A Urban Design and Landscape Referral

To: Alice Pettini, Senior Town Planner
Natasha Parasiris, Town Planner
From: Bruno Pelucca, Senior Urban Designer
Rui Liu, Senior Landscape Architect
File Ref: **DA 30-2024**
Address: **206-214 Lakemba Street, Lakemba**
Date: 30 September 2024

Summary of Recommendations: **Not supported**

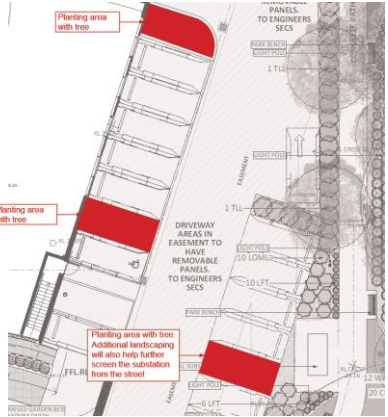
<p>The proposal has only shown <i>Trachelospermum jasminoides</i> 'Tri-Colour' for the balcony planting on level 1 and 2. The proponent should consider using a variety of shade tolerant species such as a combination of <i>Dianella spp</i>, <i>Liriope spp</i>, <i>Lomandra</i> 'Tanika', and <i>Poa labillardieri</i> to create more diversity within the planter beds and improve visual amenity.</p>	<p>Updated landscape architecture plans.</p>	<p>Partially addressed</p> <p>Whilst the proponent has introduced '<i>liriope</i>' into two of the planter beds on level 2. The development still uses monoculture planting in level 1 and 2 planters. The proponent should introduce more planting variety into each planter to improve diversity and visual amenity of each planter bed.</p>
<p>Mark-up 1:</p>  <p>Mark-up 2:</p> 		<p>New comments on the amended landscape plans to be addressed</p> <ul style="list-style-type: none"> • The development proposes the removal of existing Tree 17. The proponent should retain this tree by removing the car park which currently intrudes into its SRZ. • The development retains all existing driveway ramps within the verge. The proponent should remove any unused driveway ramps and reinstate the verge with turf. • The landscape area between the car park and the pedestrian link path is shown as a combination of garden bed and lawn. The proponent should remove the lawn and use only planting, as the proposed lawn is too narrow and close to the footpaths to be functional. • A drainage pit is shown in the lawn adjacent to the pedestrian link and Lakemba Street footpaths (S.L 24.10). The proponent should integrate this pit into the paving design to avoid cluttering the lawn. Refer to Mark-up 1 on the left. • No tree planting has been provided in the above ground car park area, as required by Council DCP. The proponent should provide additional tree planting at the ratio of 1 tree per 5 car park spaces as per Chapter 3.2 of Council DCP. Recommended planting locations are shown in Mark-up 2 on the left.
